Subject: Objection (2) to DA2021/0668 - 95 Bower Street, Manly

Development Application to Northern Beaches Council 95 Bower Street Manly

Objection to impacts on view sharing

DA 95 Bower Street, Manly Advice on View Sharing

Views From Number 31

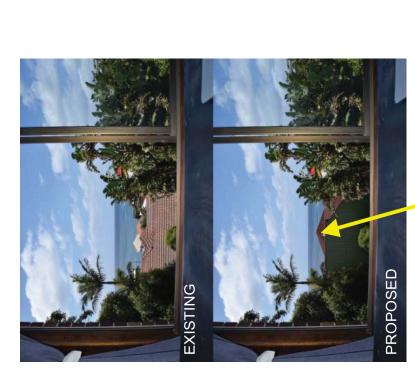
We note that the proposal breaches the height limit as a 4.6 objection for height has been lodged for the verandah gable roof facing Bower Street and we are advised that there may be localised breaches at the southern ridge (College Street). However, the extent to which the design breaches the standard is not clear from the DA documentation or the Height Plane shown on DA18 and in addition the height dimensions are related to 'assumed ground level' rather than natural ground level as required in the LEP. Council should require this documentation to be amended, as without doing so, it is not possible to determine whether and to what extent the building may breach the control and therefore whether the Clause 4.6 request can be supported. Any breach is a significant matter for consideration where is causes view loss. The building even on the applicant's own view study causes view loss and the part of the building currently agreed to be above the height standard causes view loss (refer to View 5 of VS04, on the next page of this report, where it is evident that the non-compliant part of the proposed building blocks the view of water from the first floor living area of 31 Reddall Street).

proposed building which is above the height limit View loss caused by non-compliant area of

Photograph with proposed No.95 Bower St as red outline View from No.29 Reddall St upper level balcony Objection to 95 Bower St, Manly

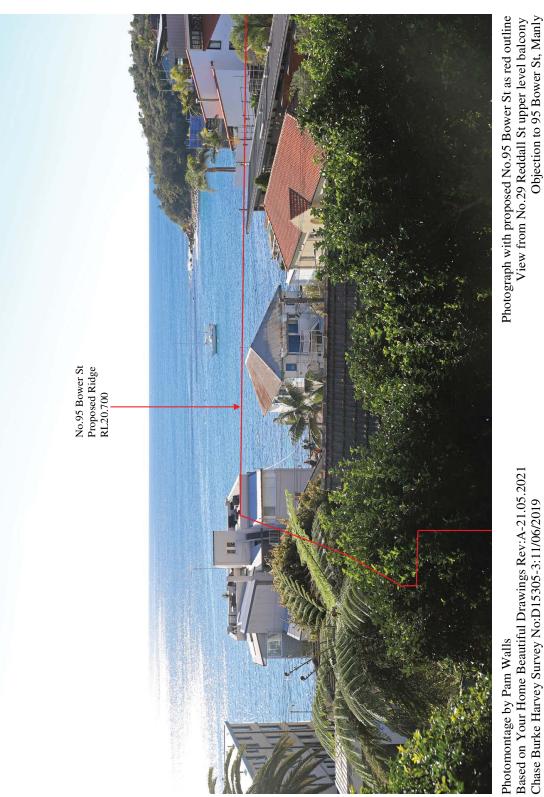
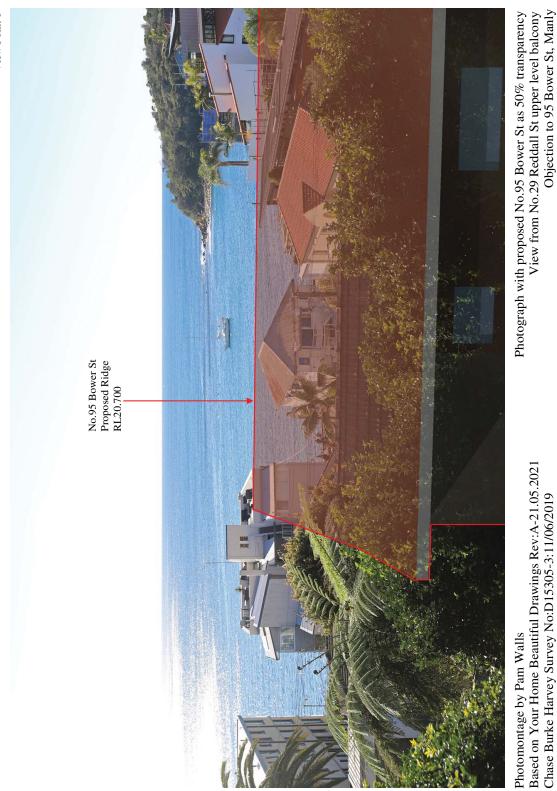
View Point 2 29 Reddall Street upper balcony The impact on the view is moderate. A flat or skillion roof design would be reasonable

View from No.31 Reddall St middle level living area Objection to 95 Bower St, Manly

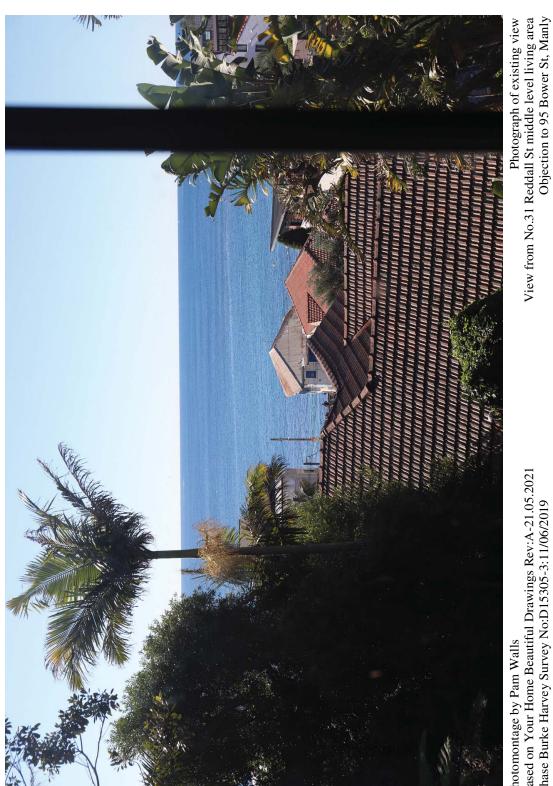
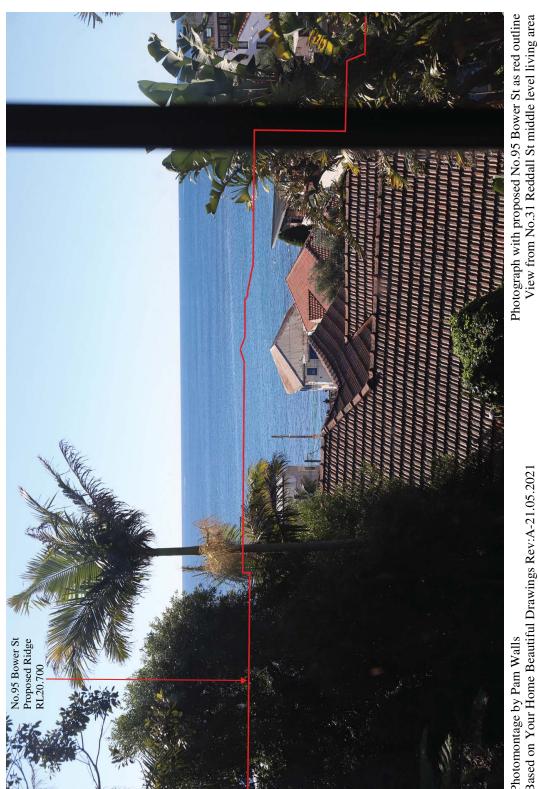
View Point 31 Reddall Street middle level living room The impact on the view is moderate to severe. A flat of skillion roof would be reasonable

View from No.31 Reddall St private open space Objection to 95 Bower St, Manly

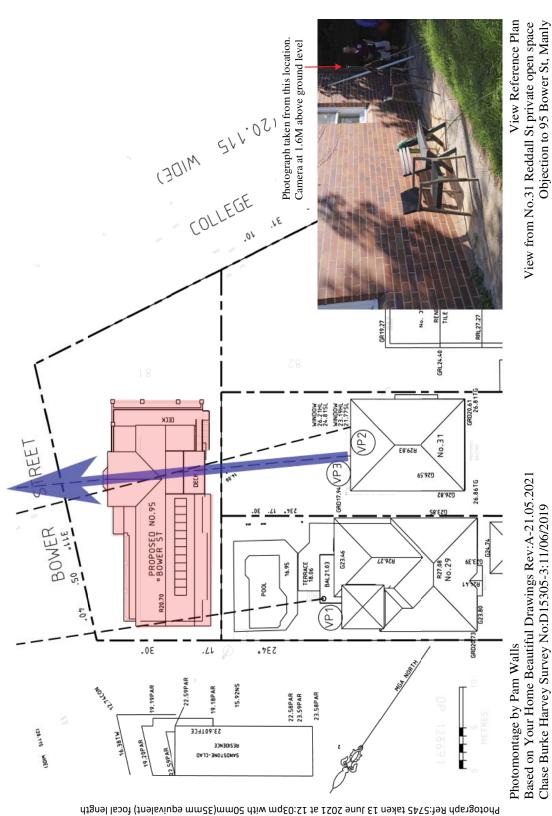
View Point 3 31 Reddall Street private open space The impact on the view is devastating and exacerbated by the roof terrace privacy screen, which should be significantly lowered or removed
